We would like to thank the reviewer for the comments and suggestions to our manuscript. In the following, we answer to the reviewer's comments and indicate the changes in the manuscript that were implemented according to the recommendations. The comments are in black. Our answers are in blue.

Referee #2:

The manuscript, "Development and deployment of a mid-cost CO₂ sensor monitoring network to support atmospheric inverse modeling for quantifying urban CO₂ emissions in Paris," provides a thorough description of the development and evaluation of a new urban mid-cost sensor monitoring network. This is a well-written document that is useful for those working on greenhouse gas quantification with urban monitoring networks.

Figure S4. The evolution of target gas injection duration in relation to the differences in CO₂ concentration between the other 4 minutes and the 3rd minute at one HPP sensor (HPP3), with a daily injection of target gas lasting 5 minutes over 26 days at LSCE.

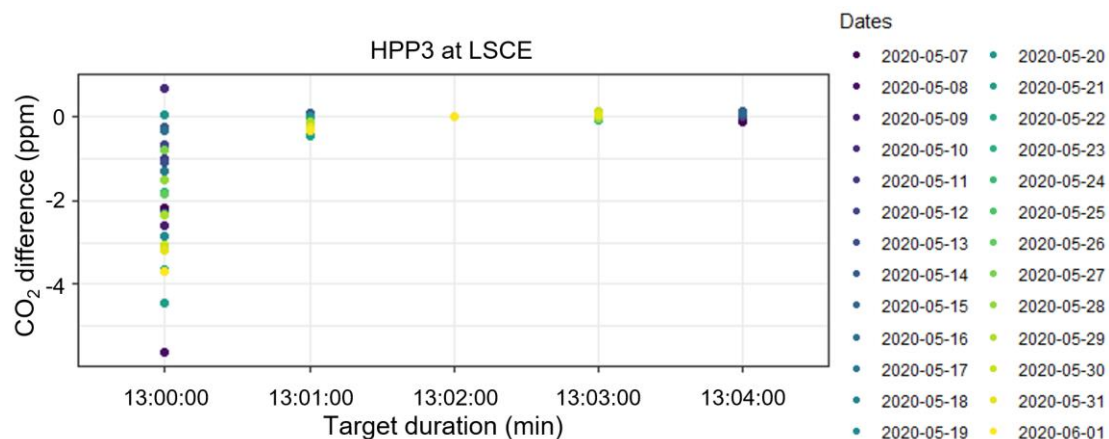
Page 5: In lines 35-37, the authors describe the target gas calibration using only 2 minutes to allow for flushing, but the calibration in parallel with the CRDS instrument requires 7 minutes to flush as described in lines 16-17. Could the authors provide justification for the shorter flushing time?

Response:

We have added the following paragraph in the supplement (Text S1 and Figure S4) to explain the settings for these two flushing times:

"To mitigate delays in sensor responses and ensure stability, thorough CO₂ flushing of the sensor cell is necessary. During the CO₂ correction coefficient IC_1 determination process, we sequentially sampled CO₂ mole fraction for a duration of 10 minutes, with 7 minutes dedicated to flushing and only the last 3 minutes of data used. During the on-site daily target gas injection for the $CO_{2\text{offset}}$ calculation, we sampled CO₂ mole fraction for a duration of 3 minutes, with 2 minutes of flushing and only the last minute of data used.

The differences in flushing times are due to two reasons. First, the CO₂ correction coefficient IC_1 is determined through a multipoint CO₂ regression using the seven mole fraction values

assigned within the 400–600 ppm range. Conversely, the CO₂ concentration in the target tank (which contains dry compressed natural air, pressurized at 200 bars and calibrated in CO₂) is supposed to be close to the ambient air CO₂ concentration on-site during midday. The step between two different CO₂ concentrations in the IC_1 determination process is greater than that during the target tank injection for drift correction, thus requiring a longer flushing time to achieve stabilization. Second, the CRDS and the mid-cost HPP sensor do not measure at the same flow rate, approximately 0.25 LPM for the CRDS and about 1 LPM for the HPP. They also have different precision targets. The CRDS sensor requires an extended period of target gas measurements to achieve a stability of less than 0.05 ppm, which is suitable for applications beyond this specific intercomparison. Therefore, the flushing time in the IC_1 determination process, when the HPP sensor measures in parallel with the CRDS, is expected to be longer. Before implementing this setting, we carried out several sensitivity tests on the sensor performance with a daily injection of target gas lasting 5 minutes at LSCE laboratory. The following figure shows the evolution of target gas injection duration in relation to the differences in CO₂ concentration between the other 4 minutes and the 3rd minute at one HPP sensor (HPP3) over 26 days. It demonstrates that a 3-minute target gas injection, specifically utilizing the 3rd minute data, proved to be sufficient. The added value of the 4th- and 5th- minute injection is rather limited. Therefore, the choice of a two-minute flush serves as a good compromise between maintaining good sensor performance (ensuring a target accuracy of 1 ppm) and minimizing gas consumption (thereby extending the lifespan of the tank and reducing associated maintenance requirements).”
